We are proposing a change in your area

Reference	TR48-26 Oriental Parade, Oriental Bay – Pedestrian (Zebra) Crossing Improvements & No Stopping At All Times
Location – where we propose to make the change	No.245 Oriental Parade, Oriental Bay, Wellington
What we'd like to do	• Install a kerb buildout on the northern side of the pedestrian zebra crossing at No.245 Oriental Parade, install an upgraded central physical island and kerb ramps, with compliant tactile pavers, and minor adjustment to the resident's parking space outside No.244A Oriental Parade. Remove one P5 parking space outside No.252 Oriental Parade.
Why we are proposing the change	• We have received safety concerns from the community regarding limited sight lines at this pedestrian zebra crossing, specifically noting the obstruction by existing parked vehicles. A safety assessment confirmed that the Crossing Sight Distance (CSD) is currently non-compliant for pedestrians and drivers on both the northern and southern sides of the pedestrian zebra crossing. There is also recent crash record at this location, including a vehicle hitting an e-scooter on the crossing due to poor visibility, which resulted in minor injury. •

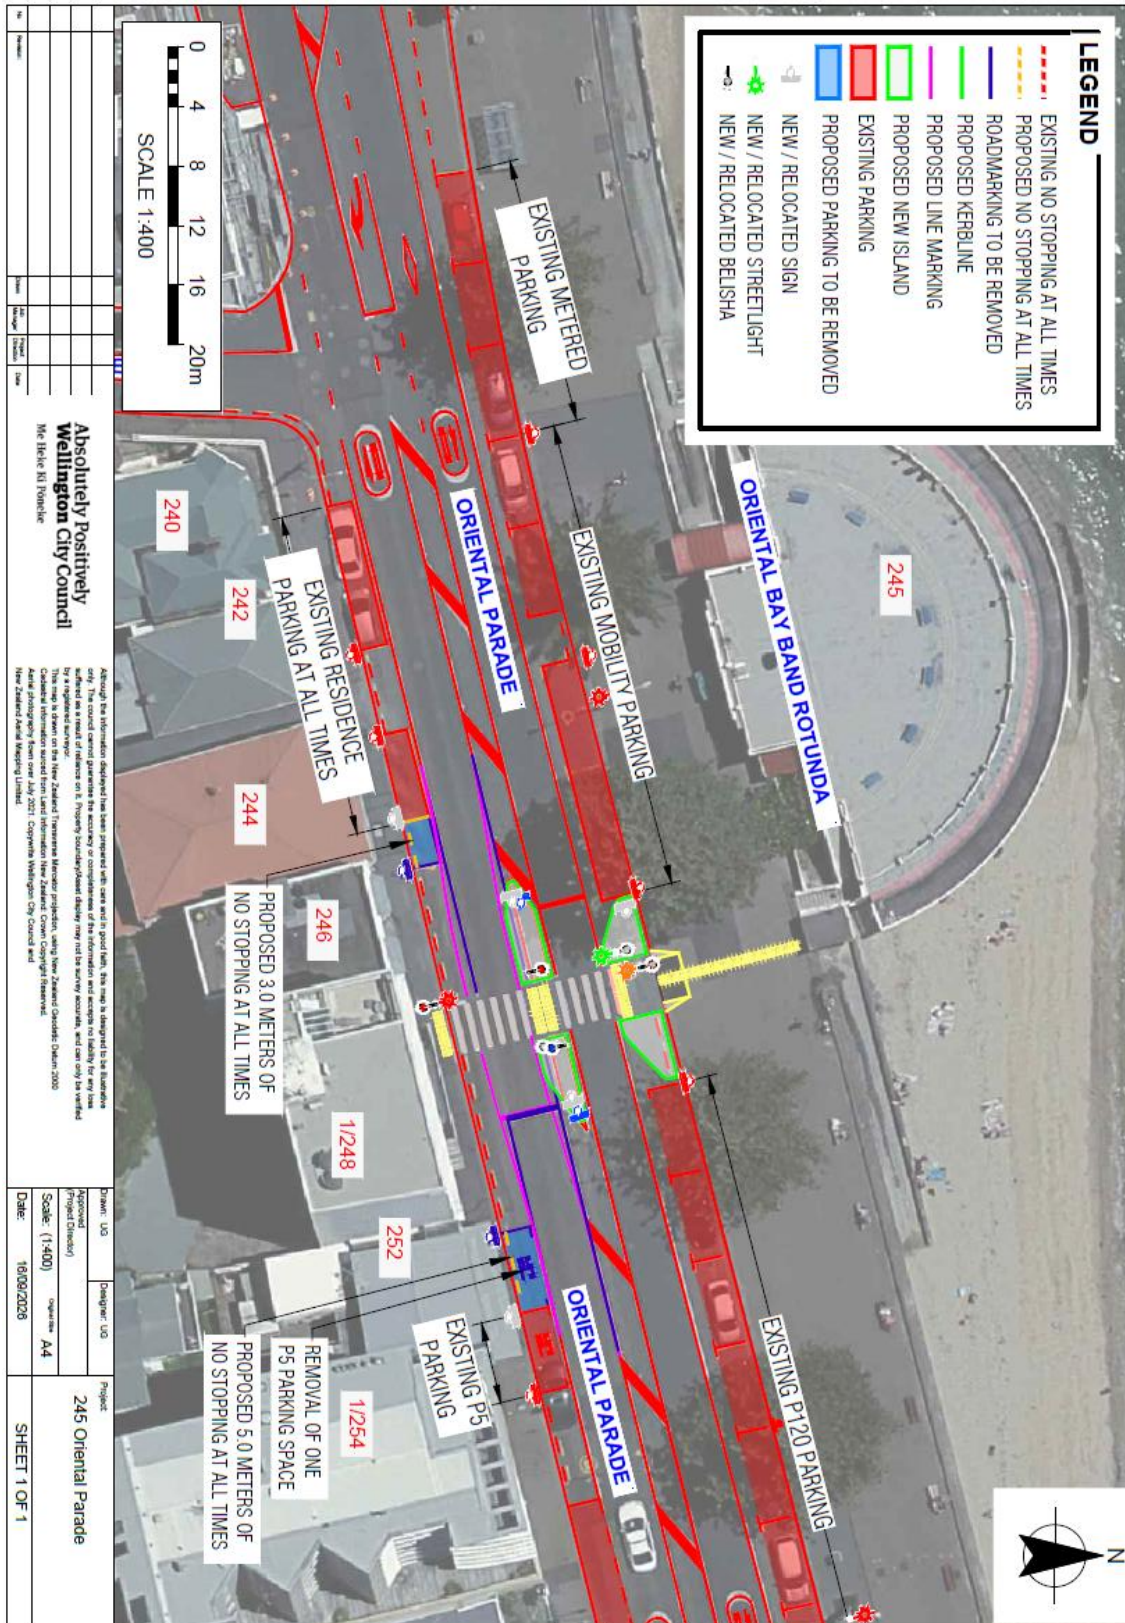
Impact	• Improves safety and accessibility for pedestrians and micro-mobility users. • Net parking impact – shortening the existing resident's parking bay outside No.244 Oriental Parade by 3.0m and the removal of one P5 parking space outside No.252. However, it is worth noting that once the construction at Band Rotunda is finished, the current construction loading zone will be removed and public parking will be reinstated in the area after construction completion. • When the construction at Band Rotunda is complete (scheduled for 2027), there would be opportunity to remove the temporary construction loading zone and revert it back to 3 to 4 parallel parking spaces on the northern side, immediately west of the zebra crossing. This will be reviewed by WCC in 2027. • Pedestrian impact - Positive. Crossing distance is shortened, and inter-visibility between drivers and pedestrians is significantly improved.
